Response overview

"Spatiotemporal dynamics of Sentinel-2 NDVI as indicators of bio-hydromorphological interactions: implications for river management"

Review for: Spatiotemporal dynamics of riparian vegetation NDVI as indicators of bio-hydromorphological interactions

Figure 12: Relationship between annual maximum greenness / h_0 and annual maximum water level (h_0 : the relative elevation at which the greenness ratio equals 0.5).

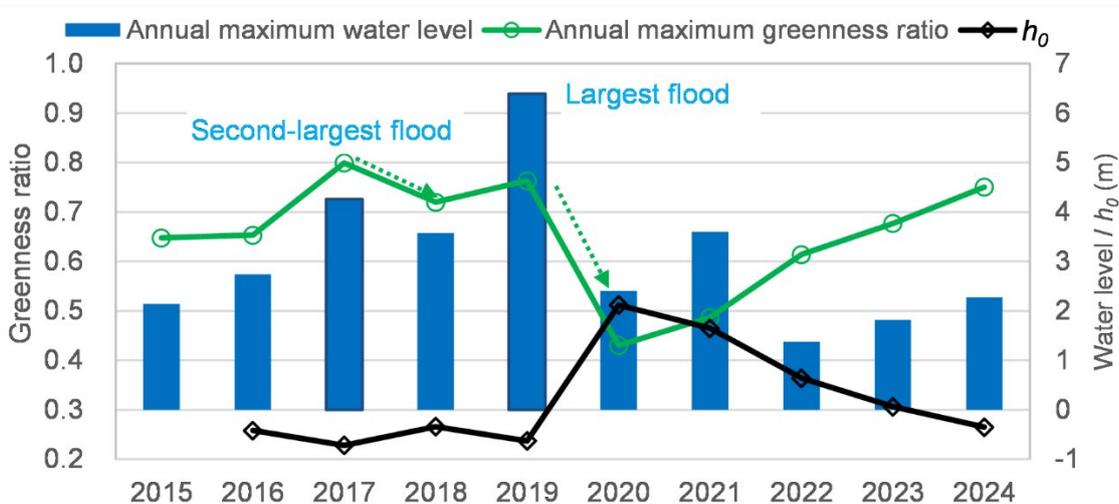
Fig 9 help the reader and state again what h_0 is. Combine with Fig 7 (put the panels together in one multipanel figure at the same scale)

Figure 9: “waterlevel” change to “water level” in legend and also h_0 should include the subscript.

Figures 7 and 9 have been combined into a single multi-panel figure on a consistent scale (Figure 12, p. 12). The definition of h_0 (the relative elevation at which the greenness ratio equals 0.5) has been added to the figure caption to improve clarity and readability.

The legend in Figure 12 (Figure 9 in the previous version) was revised by changing “waterlevel” to “water level” and formatting h_0 with the proper subscript throughout the figure and caption. The revised figure is provided on p. 4 of this response file.

Figure 10: Annual maximum NDVI averaged within each 0.5m relative elevation zone along the transect.

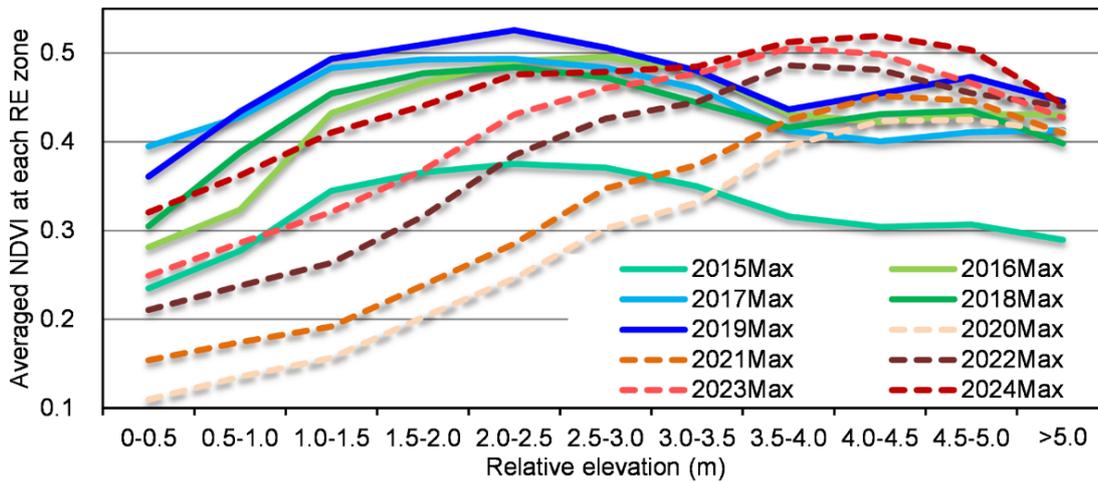
Fig 10 explain RE again in the caption. I suggest that this figure is much more readable if it is turned into a line plot with lines for all the years and RE on the horizontal axis. These will then be much easier compared.

Figure 10: Again, a more descriptive caption would be helpful, for example, explicitly state what the blue circles are indicating.

Figure 10 has been revised into a line plot, with relative elevation (RE) shown on the horizontal axis and individual lines representing different years, making interannual comparisons clearer. The figure caption was also updated to redefine “RE”. (p.11)

Figure 10 was revised into a line plot. The caption was expanded to explicitly explain. The revised figure is provided on p. 5 of this response file.

Figure 11: The relationship between seasonal dynamics of greenness ratio and temperature and precipitation.

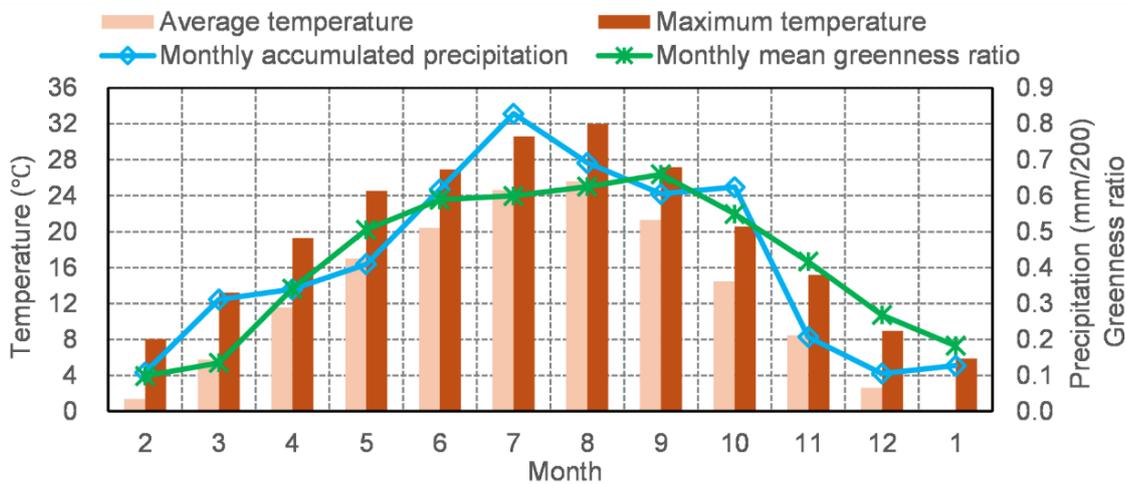
Fig 12 and Fig 13 can also be combined in a multipanel figure with exactly the same x-axis for better analysis by the reader

Figure 12: Cosine is capitalized but vegetation is not. Keep consistent for all figures.

We agree that combining Figures 12 and 13 improves readability. In the revised manuscript, these figures are merged into a single multi-panel figure with a consistent x-axis to facilitate direct comparison of seasonal patterns (Figure 11, p. 11). Because the purpose of the phenological analysis is to identify the timing (“when”) of vegetation cutting to enhance conveyance capacity, we focus on the month of peak NDVI and vegetation cover. To avoid obscuring the paper’s scope, we removed the cosine-model fitting included in the previous version.

To improve clarity and maintain a management-oriented scope, we merged Figures 12 and 13 into a single multi-panel figure with a consistent x-axis for direct comparison of seasonal patterns (Figure 11 is provided on p. 5 of this response file). Because the phenological analysis is primarily intended to identify the timing (“when”) of vegetation cutting to enhance conveyance capacity, we now focus on the month of peak NDVI and vegetation cover rather than on parametric curve fitting. Accordingly, we removed the cosine-model fitting from the revised manuscript.
